Broadcast Products Technical Bulletin 20-2002-167

DATE: **July 15, 2002**SUBJECT: **STATUS INDICATOR BLINKS RED;
FILTERS NEED CLEANING AFTER 24 HOURS**MODEL: **PFV-HD300**SERIAL NO: **ALL**

Figure 1

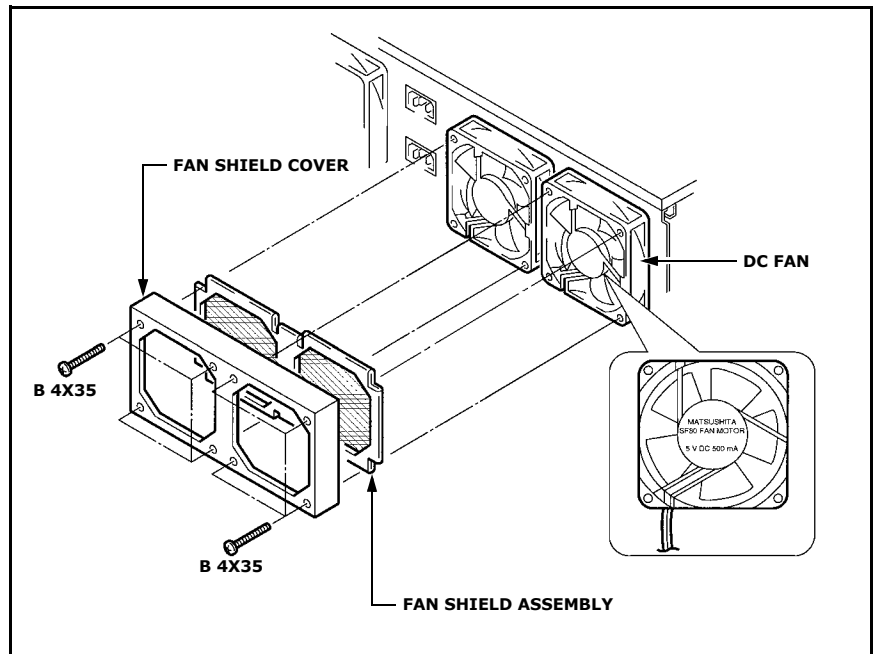
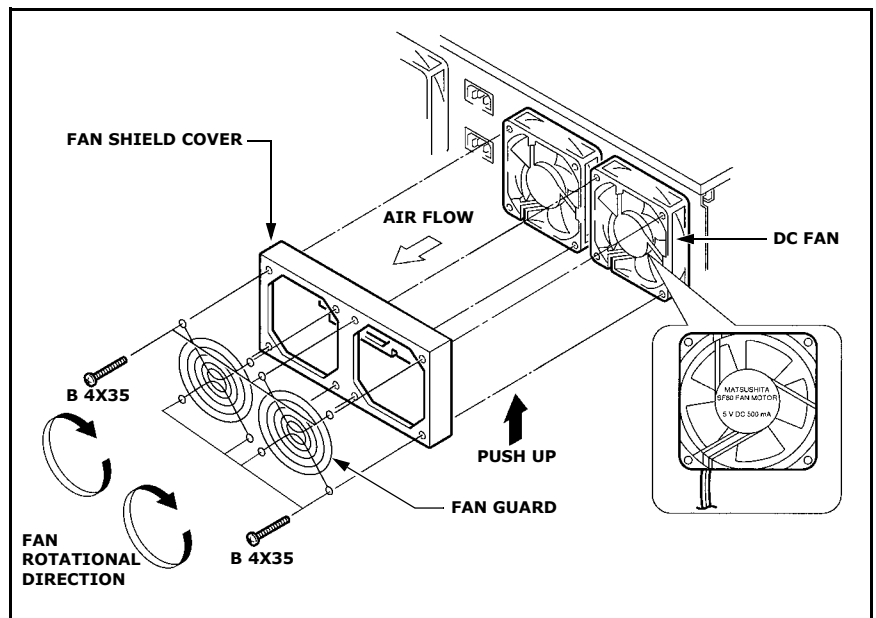
If the unit is operating in high temperature or dusty environments and the filters need to be cleaned again after 24 hours, replace the fan shield assembly with a fan guard assembly as described in the following modification procedure.

1. Remove the fan shield cover and the fan shield assembly by removing eight screws. (See Figure 1.)
2. Discard the fan shield assembly.
3. Install the DC fan, fan shield cover, and fan guards as shown in Figure 2.

- Take care to install the DC fan correctly so that:
 - The fan rotates in the proper direction.
 - The fan harness is not pinched by the fan shield cover.
- Do not discard the fan shield cover, which is required to prevent unwanted radiation.
- Install the fan shield cover while pushing it up.
